ALTO MAIPO**OWNER'S INSTRUCTION**

PHAM-PLN12-INS-0003

Contract: ☐ AM-CO610/620B ☒ AM-CO630/620A SI 6355/ N° 01057

Grouting Instruction L1 FIRST GROUT FAN

Position of Grout holes:

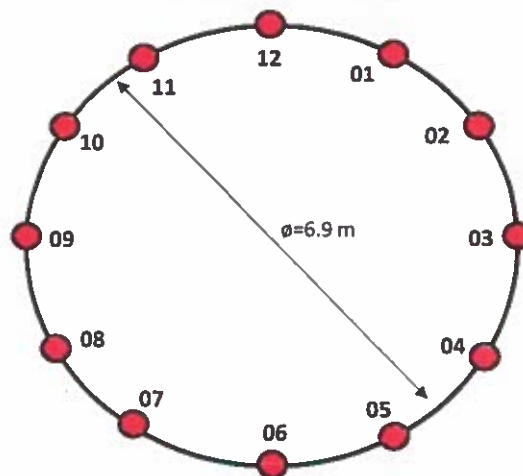
The contractor is here with instructed to carry out chemical pregrouting, following the guidelines of attachment sheet and SI-6355-01013.

1- DRILL HOLES FROM #01 TO #12 IN SEQUENTIAL ORDER.

2- MEASURE WATER INFLOW AND PRESSURE IN ALL HOLES.

3- GROUT ALL HOLES AS INDICATED IN SI-1013.

N° of Grout holes	12
Grout holes length (m)	30
Grout hole angle ref Tunnel axis	6° - 10°

1- If great discharges occurs (>10 L/s), stop drilling and grout.

2- Postgrouting exploratory holes shall be evaluated by OE/Strabag.
